Access Compliance Report

Public Rights-of-Way

(Curb Ramps)

Intersection ID: 16396	Main Street: WENDOVER_RD	Cross Street: BEAL_ST	Location: SE
ADA ID: 093FAD0BD0B1	Ramp Type: Perp	Initial Pass/Fail: Fail	Overall Compliance: No
Severity Score: 22.5			
Codes/Mitigation Info/Possible Solution		Field Measurements/Component Compliance

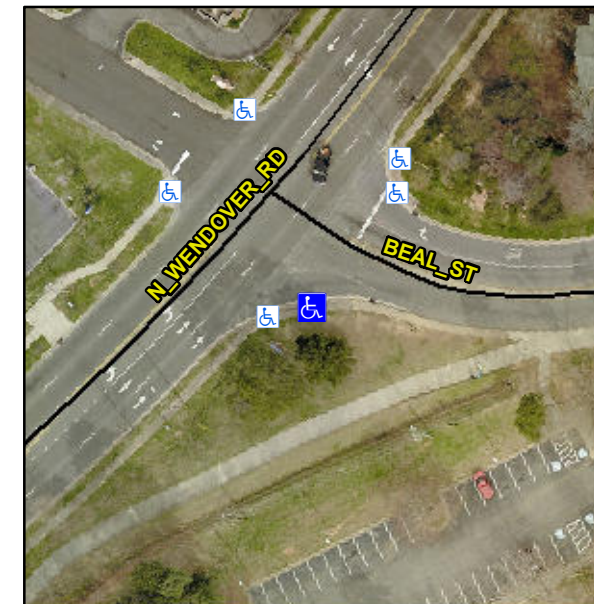
Not Found, R304.5.1, R304.2.2, R304.5.3

Compliance	Description	Data	Compliance	Description	Data
N/A	Ramp Length (in)	60.0	No	Ramp Slope (%)	11.5
No	Ramp Width (in)	44.0	No	Ramp XSlope (%)	3.5
N/A	Flare Type LT	N/A	N/A	Flare Type RT	N/A
N/A	Flare Slope LT (%)	N/A	N/A	Flare Slope RT (%)	N/A
N/A	Flare Traversable LT?	N/A	N/A	Flare Traversable RT?	N/A
N/A	Landing Length (in)	N/A	N/A	DWS Provided?	N/A
N/A	Landing Width (in)	N/A	N/A	DWS Contrast?	N/A
N/A	Landing Slope (%)	N/A	N/A	DWS Length (in)	N/A
N/A	Landing X Slope (%)	N/A	N/A	DWS Full Width?	N/A
N/A	Landing Curb? (Y/N)	N/A	N/A	DWS Offset (in)	N/A
N/A	Shared Landing?	N/A			
N/A	Gutter Ponding?	N/A	N/A	Gutter Slope (%)	N/A
N/A	Gutter Lip Ht (in)	N/A	N/A	Gutter X Slope (%)	N/A
N/A	Painted X Walk1?	No	N/A	Painted X Walk2?	N/A
	X Walk 1 Direction	To NE		X Walk 2 Direction	N/A
N/A	X Walk 1 Width (in)	N/A	N/A	X Walk 2 Width (in)	N/A
	X Walk 1 Slope (%)	0.7		X Walk 2 Slope (%)	N/A
	X Walk 1 X Slope (%)	5.8		X Walk 2 X Slope (%)	N/A

Remove & Replace Entire Ramp.
